**GS# 321-271**

**Mississippi State Penitentiary Wastewater Treatment Facility Improvements**

**Pickering Firm, Inc. Project 25340.03**

**ADDENDUM #2**

S1.03

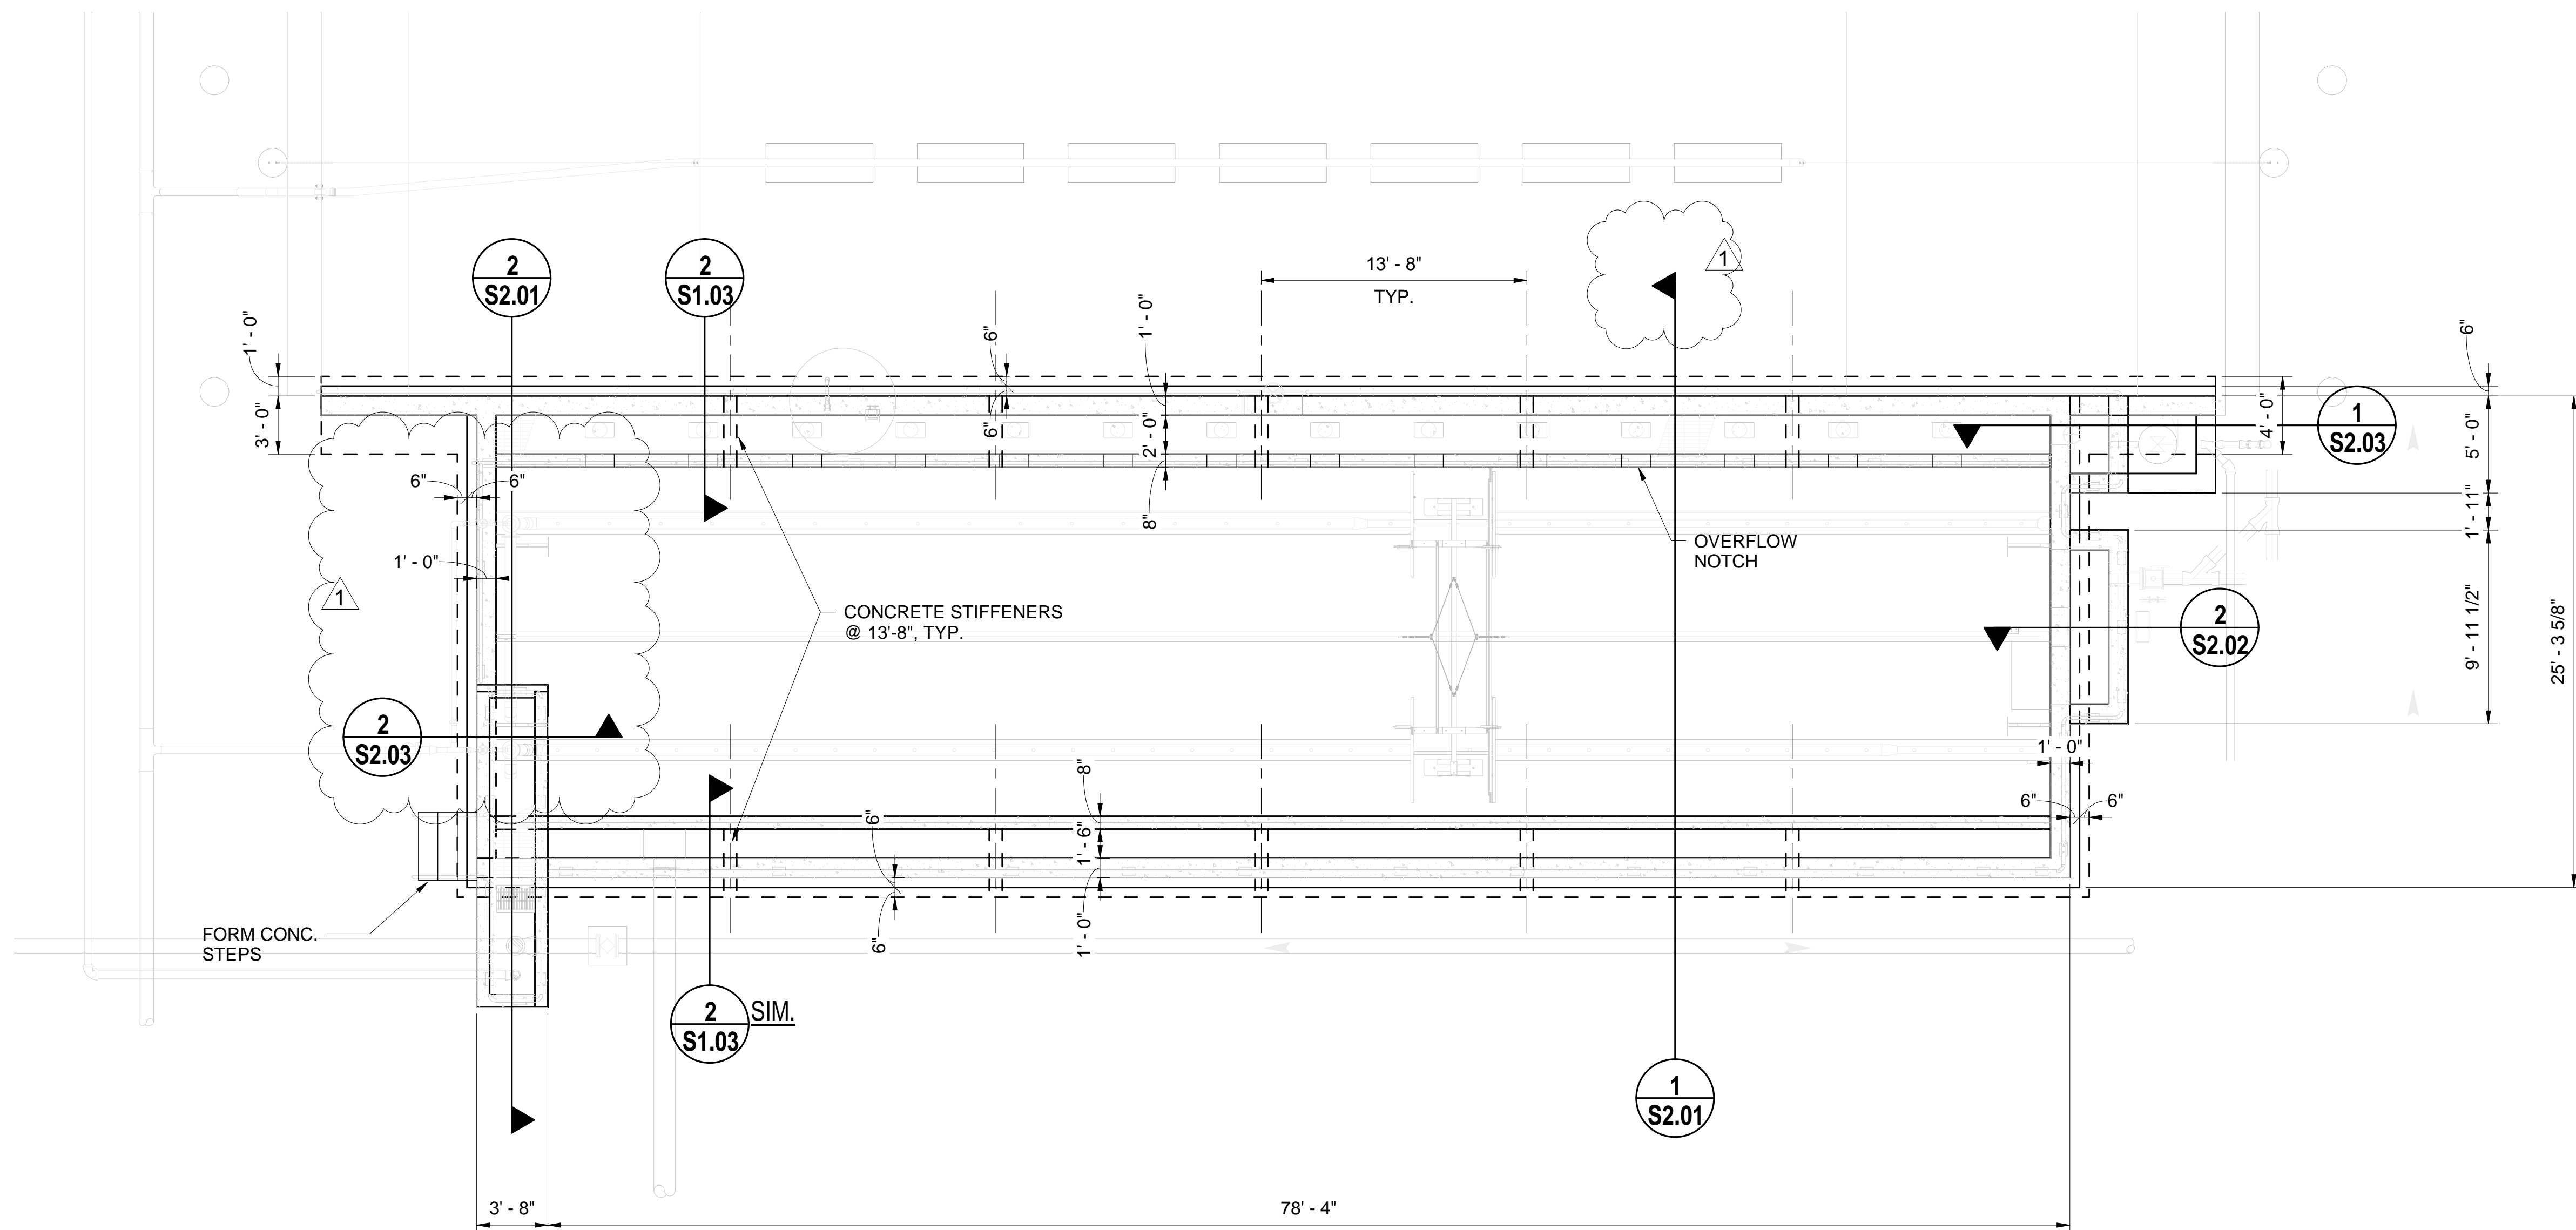
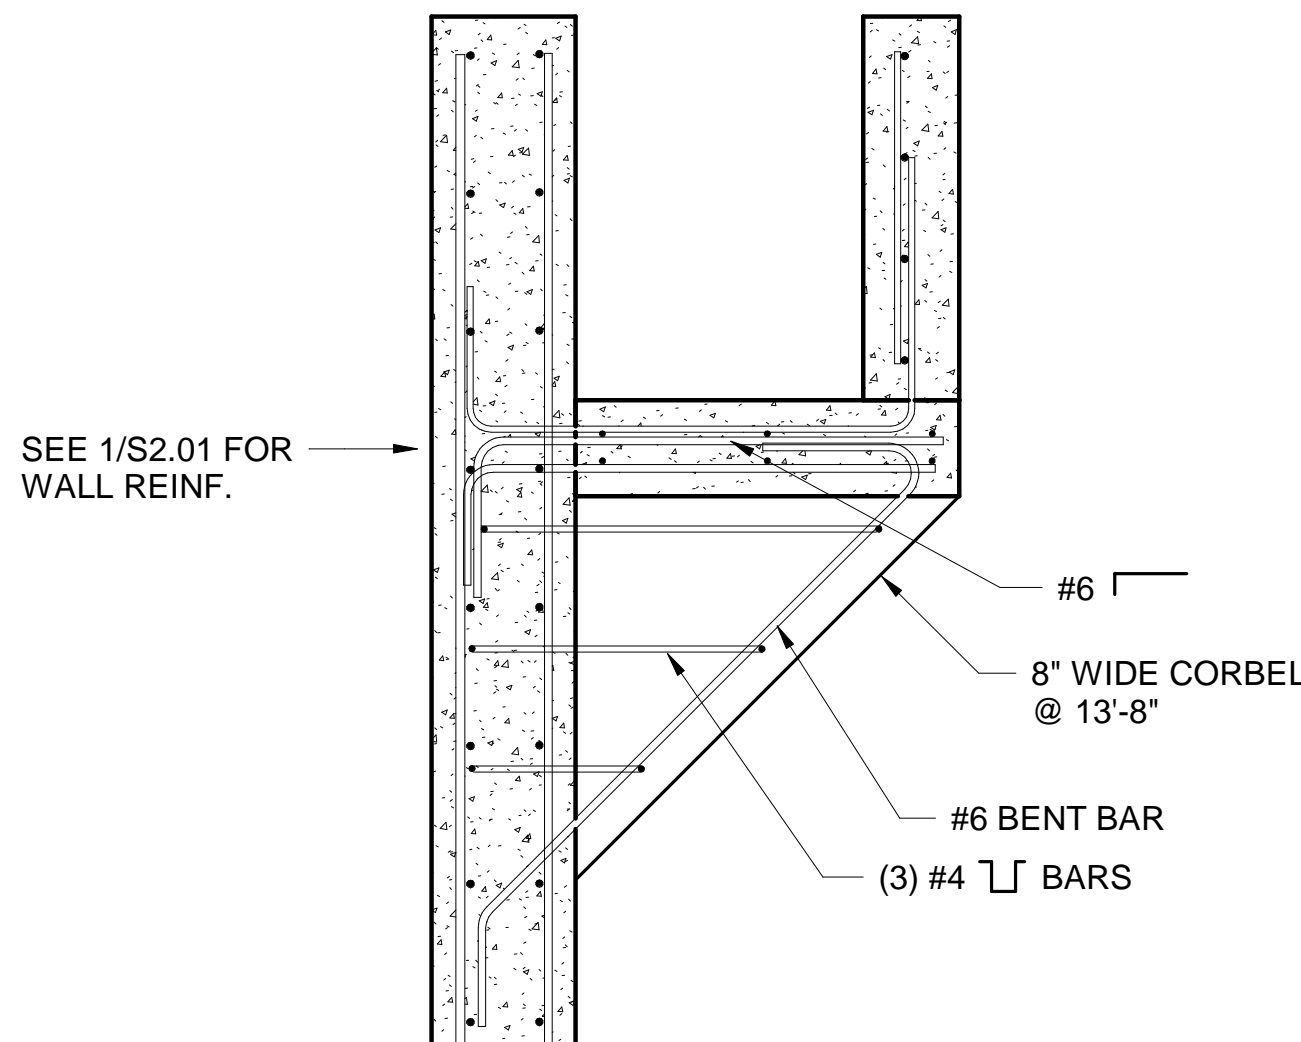
14. Sheet S1.03: Is the orientation of the cut for Section 1 – S2.01 correct?

15. Sheets S1.03 and S1.04: The cut for Section 2 – S2.03 shows a trough that does not exist on the mechanical plans. Does this trough exist? If so, how does this trough interface with the elevated RAS/WAS structure?

Reverse direction of cut for Section 1 – S2.01 on Sheet S1.03.

See revised Sheets S1.03 and S1.04 included with this addendum.
